Skagit River Project - Environmental Input to Design of Downstream Levees.

5 September 1978  
Mettling/pb/3624

## SKAGIT RIVER LEVEE AND CHANNEL IMPROVEMENT PROJECT

**AREA 4**

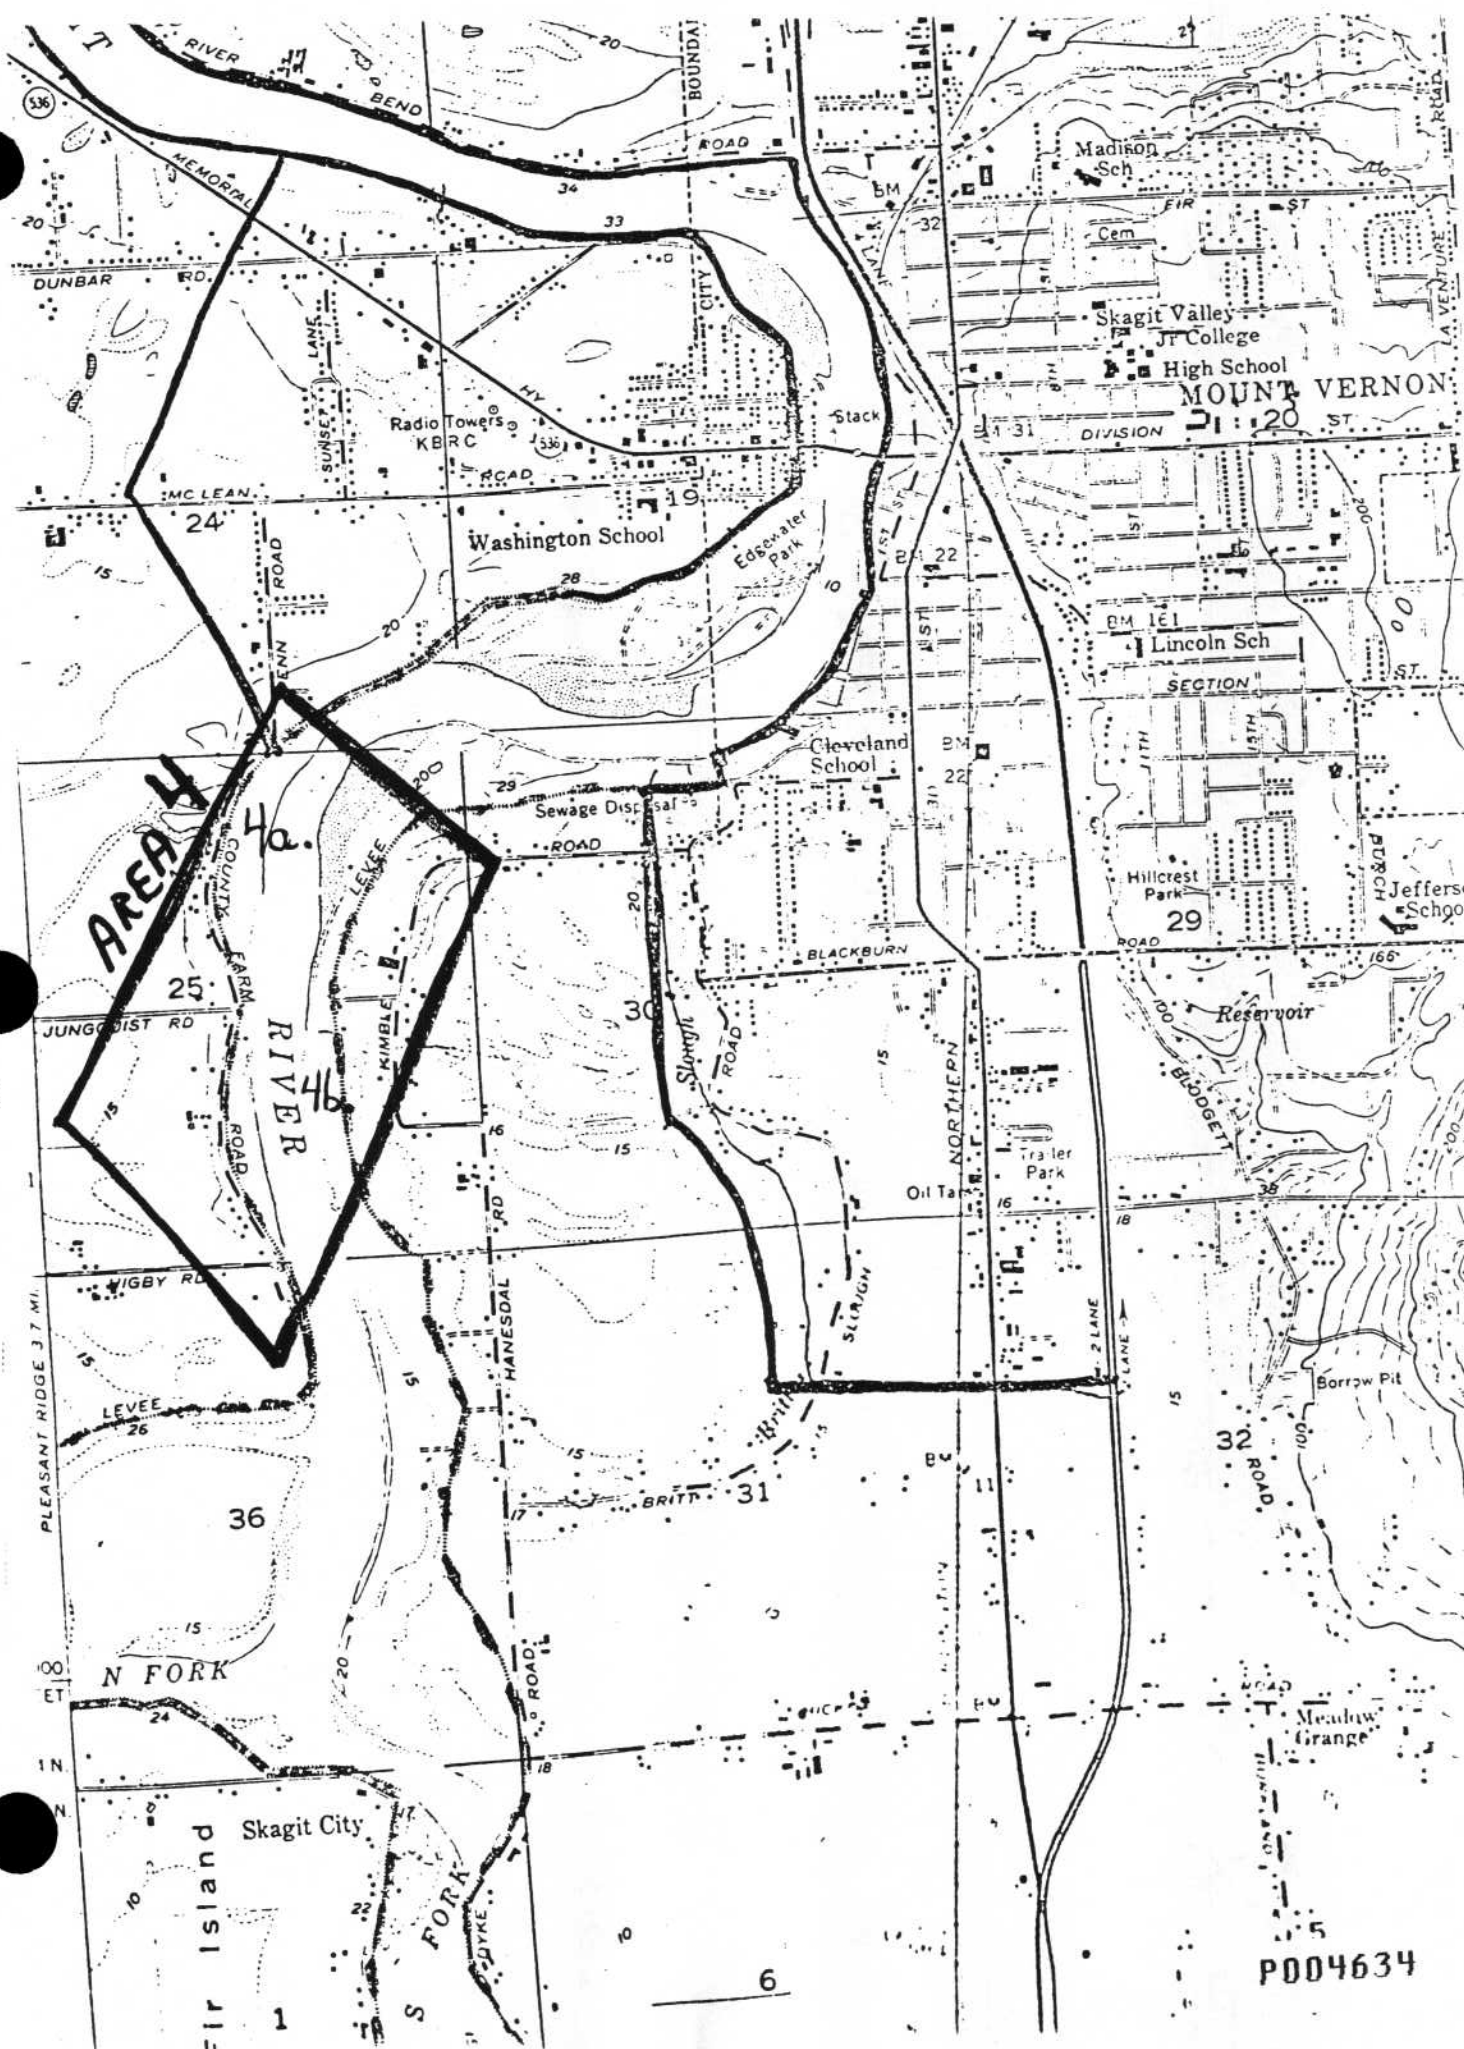
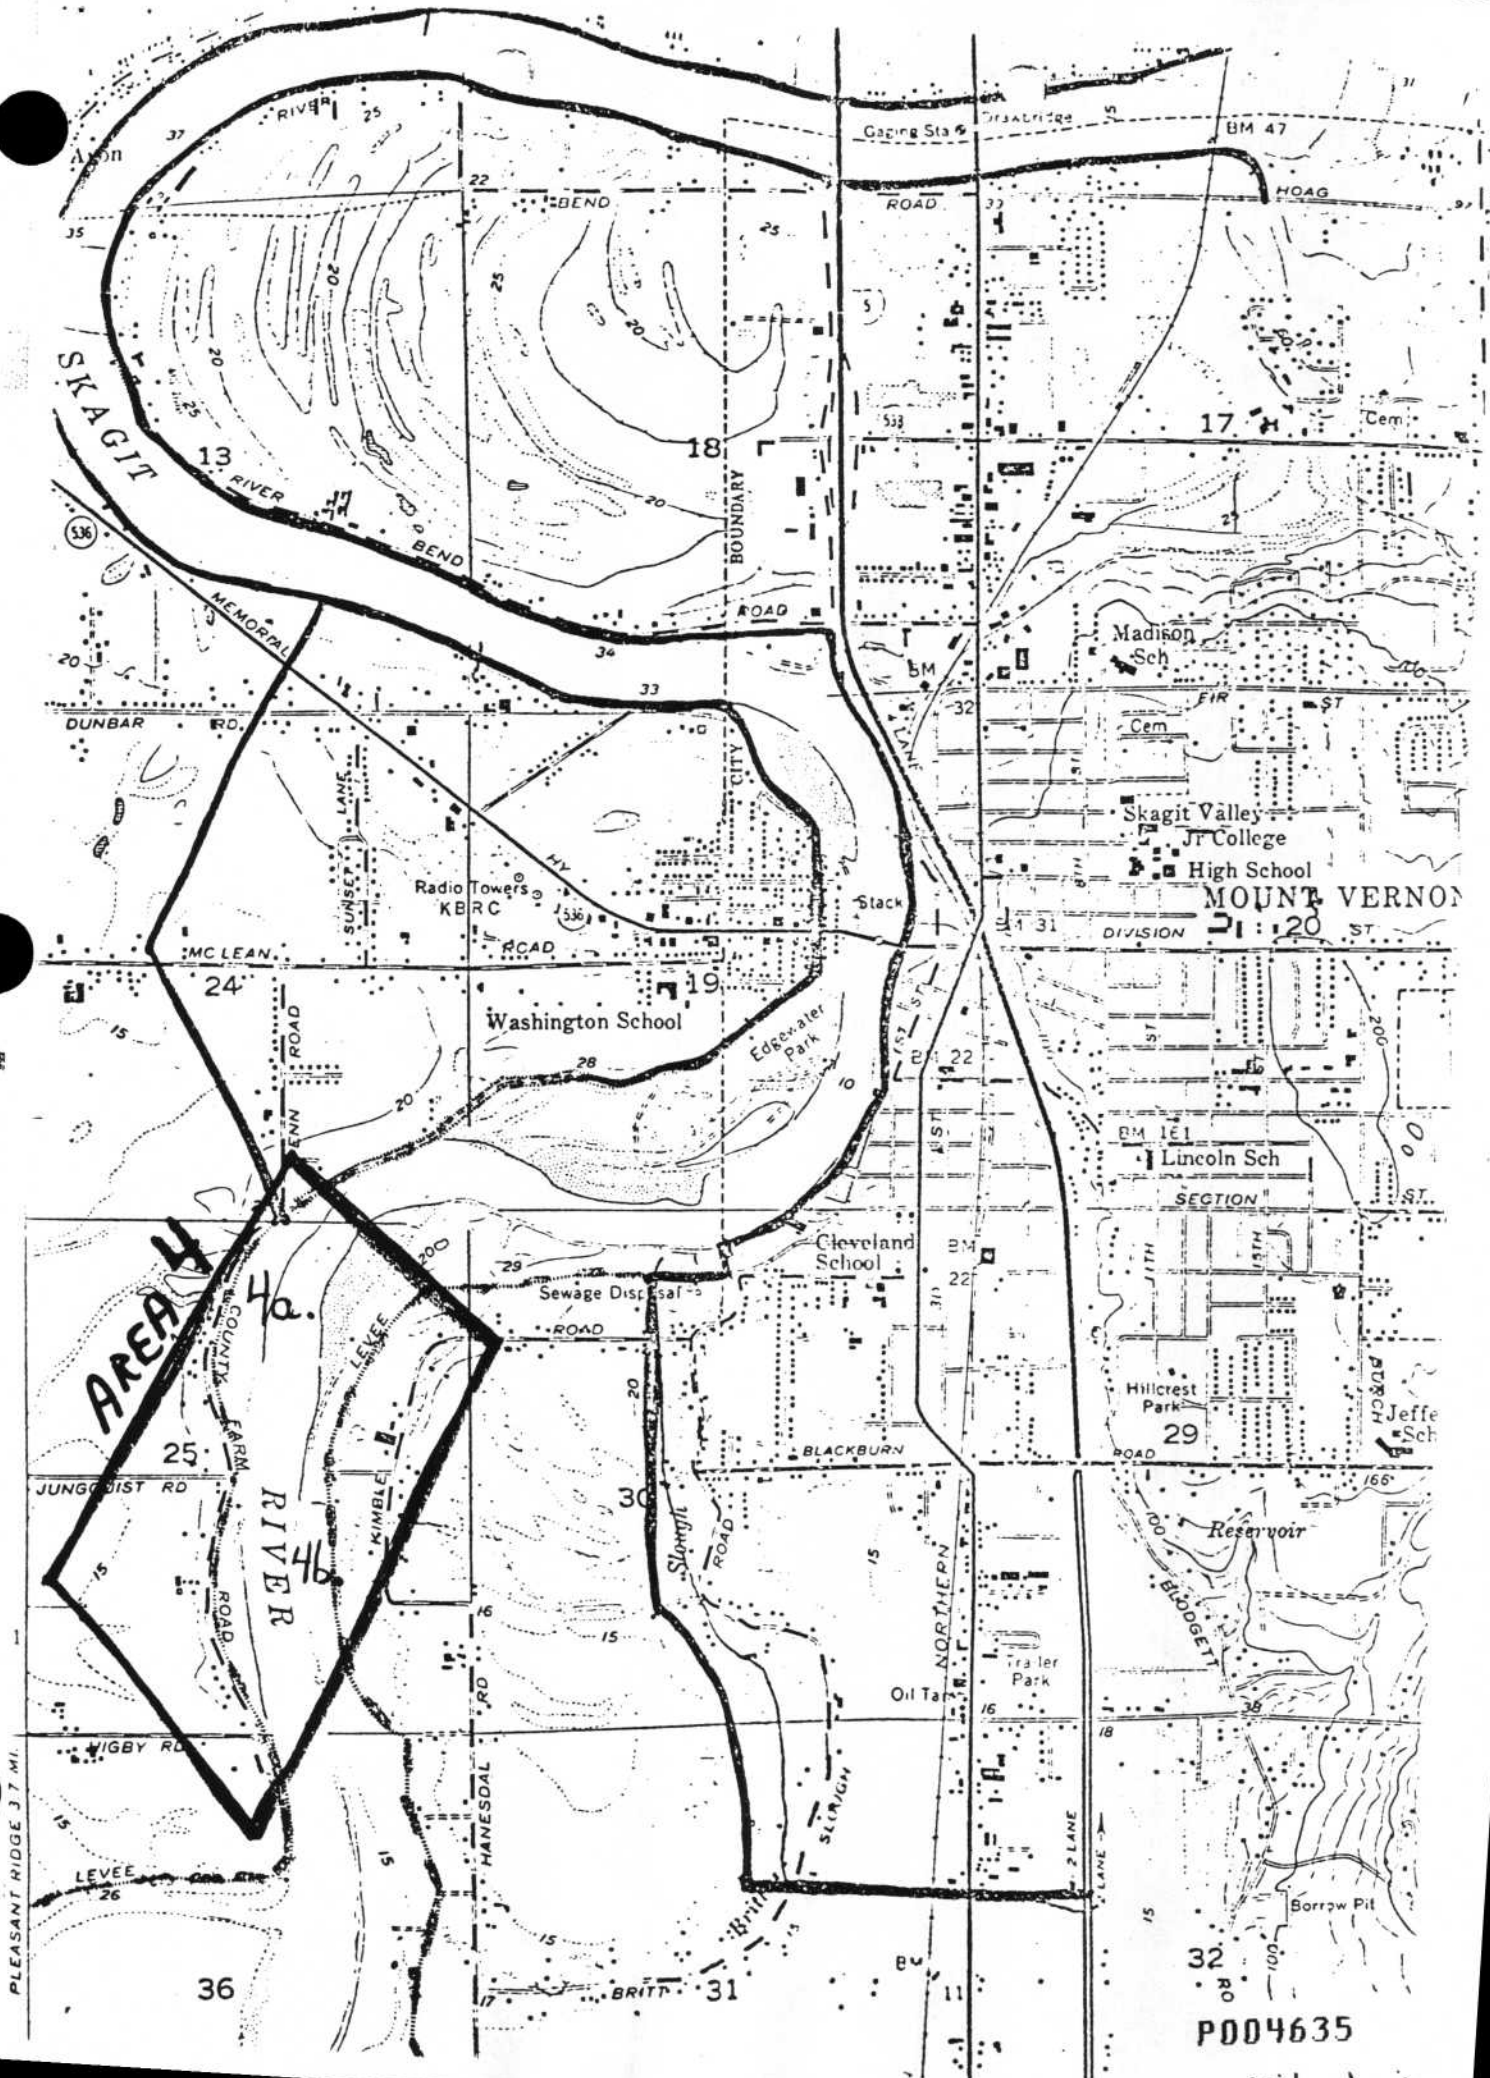
Area 4. Main Stem, Stations 680 - 720, left bank; Stations 680 - 725, right bank.

(a) Station 680 - 725, right bank. That the necessity for adding additional riprap riverward at this bend be reexamined. If such placement is necessary, that fishermen access be provided on the riprap and that large riprap be selectively placed in the river.

(b) Station (approximately) 720, left bank. That placement of riprap in the river be avoided and that rootball and snag removal be minimized.

AREA 5

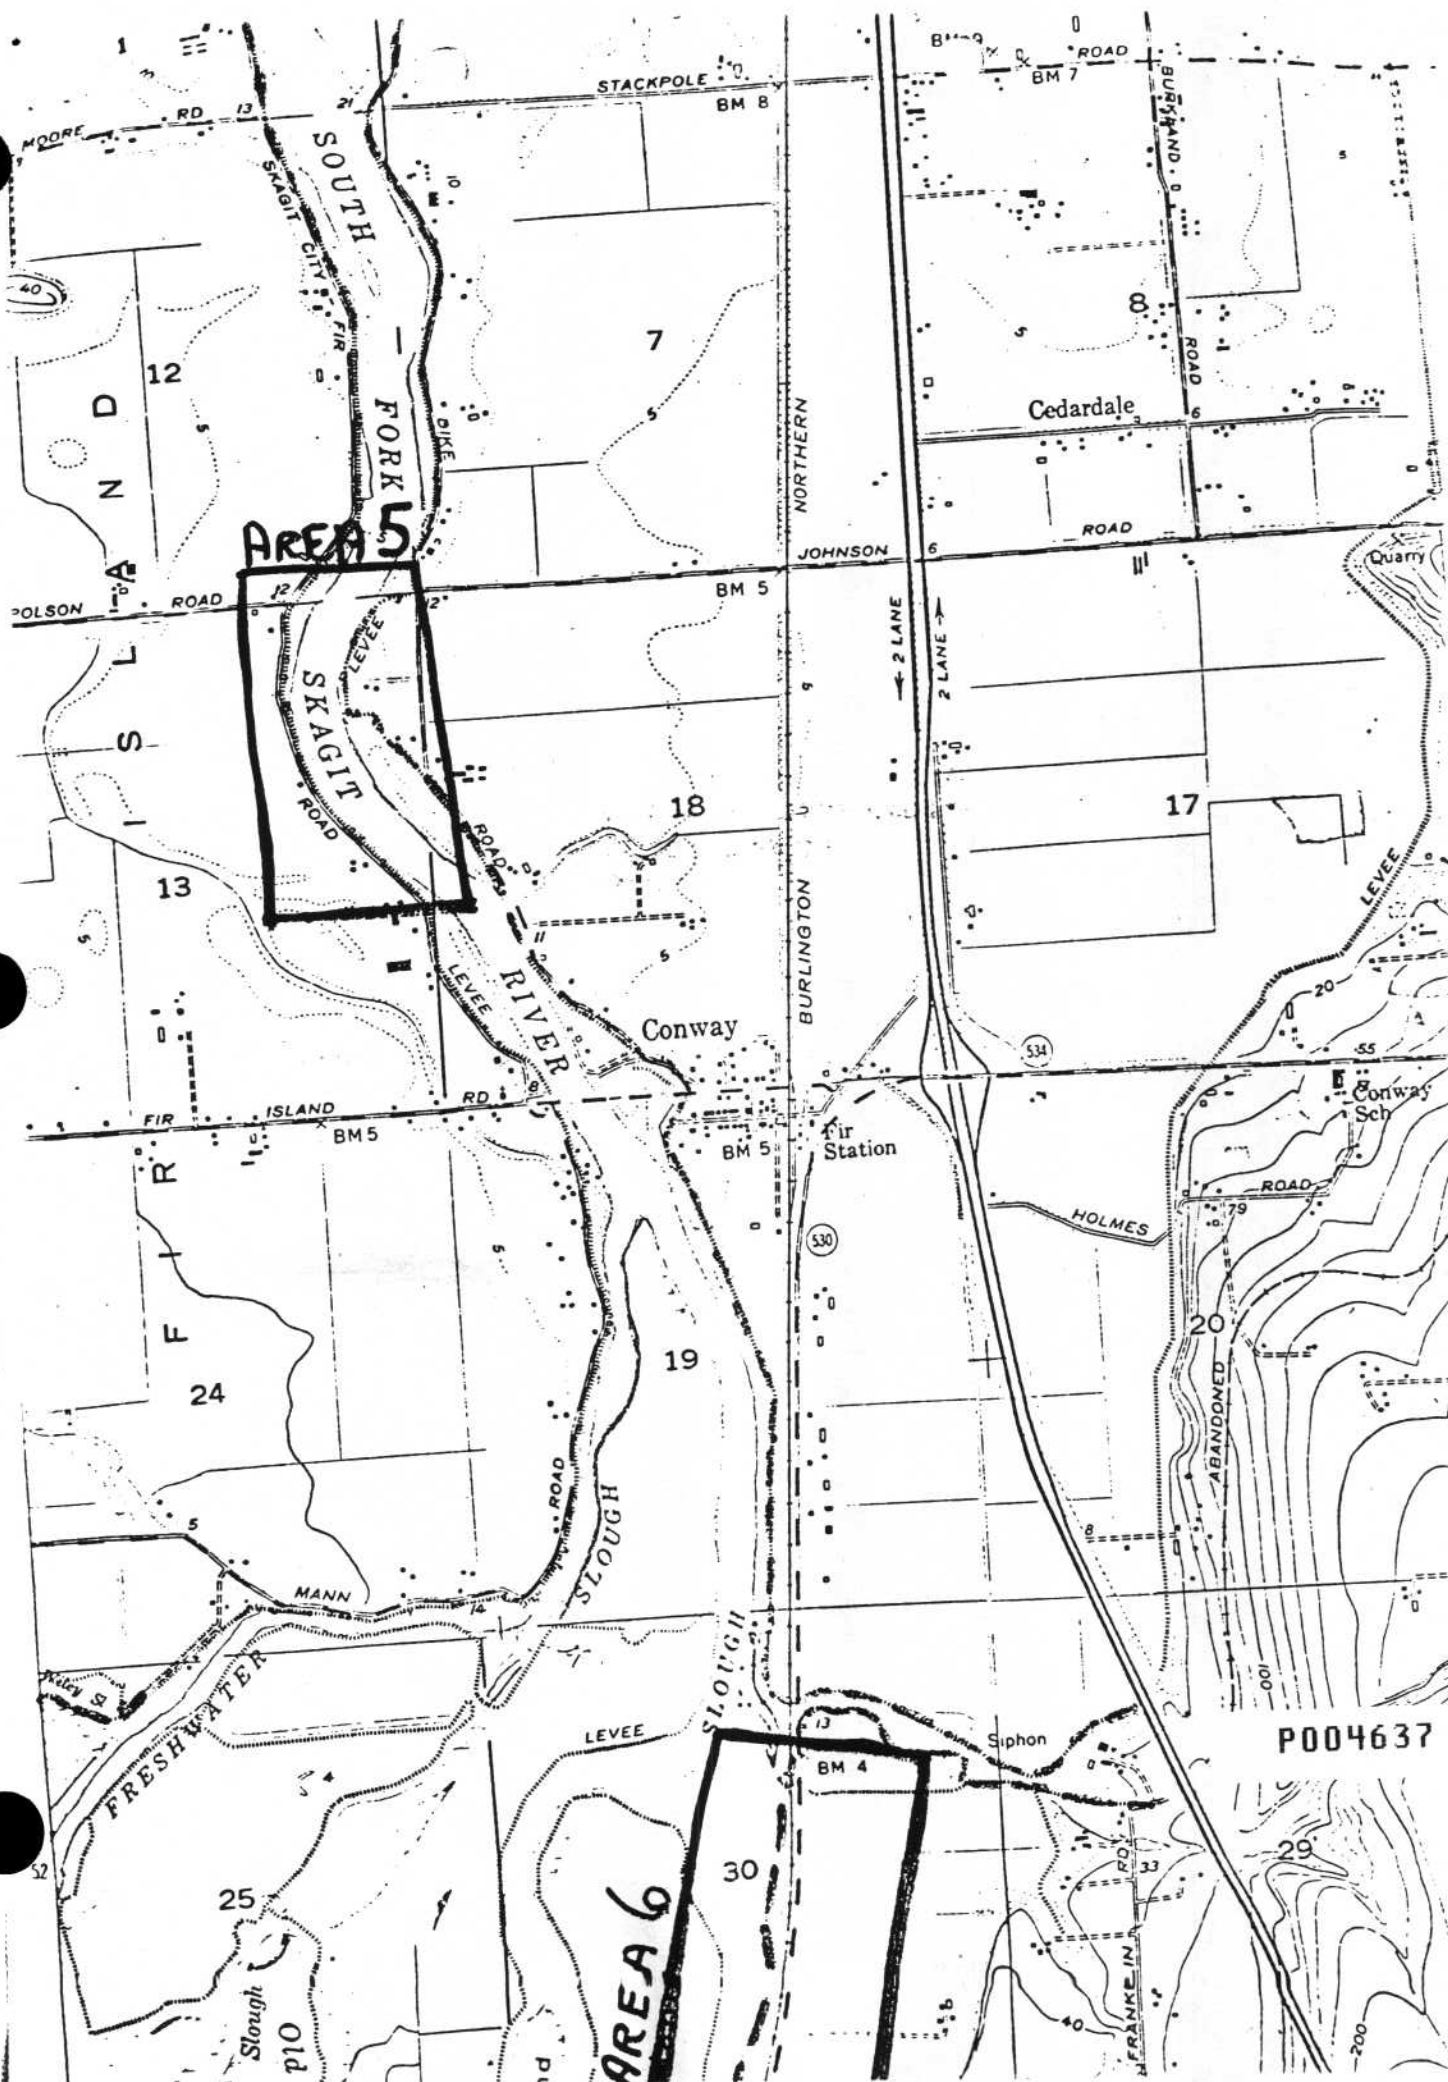
Area 5. South Fork, Stations 110 - 160, right bank. That no additional riprap be placed in the river in this reach and that the dense stand of trees along the river be left undisturbed. The contractor's drawings indicated that no riprap would be placed at this location.

Area 6. South Fork, Tom Moore Slough. Stations 1055 - 1120. That minimal encroachment riverward be considered in levee design. This is one area where mitigation planting may be necessary to restore the prime riparian habitat lost to the levee right-of-way. It is noted that the contractor's analysis indicated that no riprap would be placed either on the levees or into the river in this reach.
